Access Compliance Report

Public Rights-of-Way

Intersection ID: 13767	Main Street: E_5TH_ST	Cross Street: PARK_DR	Location: E
ADA ID: FD1551D1DA08	Ramp Type: PerpDiag	Initial Pass/Fail: Fail	Overall Compliance: No
		Severity Score: 12.5

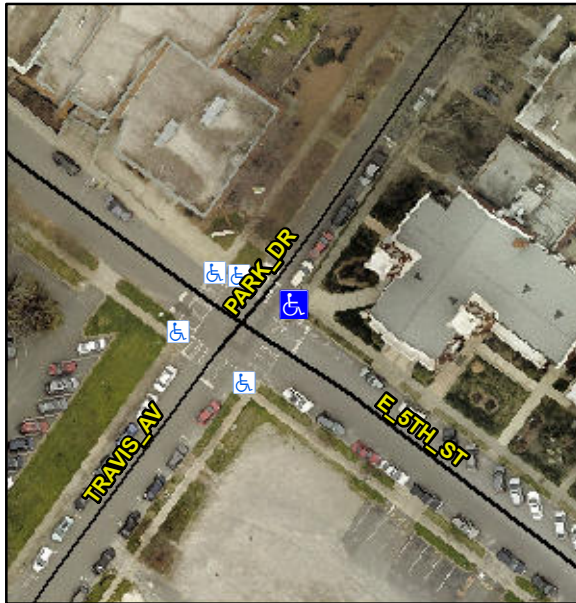
Not Found, R304.2.2

Compliance	Description	Data	Compliance	Description	Data
N/A	Ramp Length (in)	58.0	No	Ramp Slope (%)	11.0
Yes	Ramp Width (in)	80.0	Yes	Ramp XSlope (%)	2.0
N/A	Flare Type LT	N/A	N/A	Flare Type RT	N/A
N/A	Flare Slope LT (%)	N/A	N/A	Flare Slope RT (%)	N/A
N/A	Flare Traversable LT?	N/A	N/A	Flare Traversable RT?	N/A
N/A	Landing Length (in)	N/A	N/A	DWS Provided?	N/A
N/A	Landing Width (in)	N/A	N/A	DWS Contrast?	N/A
N/A	Landing Slope (%)	N/A	N/A	DWS Length (in)	N/A
N/A	Landing X Slope (%)	N/A	N/A	DWS Full Width?	N/A
N/A	Landing Curb? (Y/N)	N/A	N/A	DWS Offset (in)	N/A
N/A	Shared Landing?	N/A			
N/A	Gutter Ponding?	N/A	N/A	Gutter Slope (%)	N/A
N/A	Gutter Lip Ht (in)	N/A	N/A	Gutter X Slope (%)	N/A
N/A	Painted X Walk1?	Yes	N/A	Painted X Walk2?	Yes
	X Walk 1 Direction	To NW		X Walk 2 Direction	To SW
N/A	X Walk 1 Width (in)	111.5	N/A	X Walk 2 Width (in)	113.0
	X Walk 1 Slope (%)	2.1		X Walk 2 Slope (%)	4.2
	X Walk 1 X Slope (%)	0.3		X Walk 2 X Slope (%)	1.1

Remove & Replace Curb Ramp With Two New Directional Ramps or Equivalent.
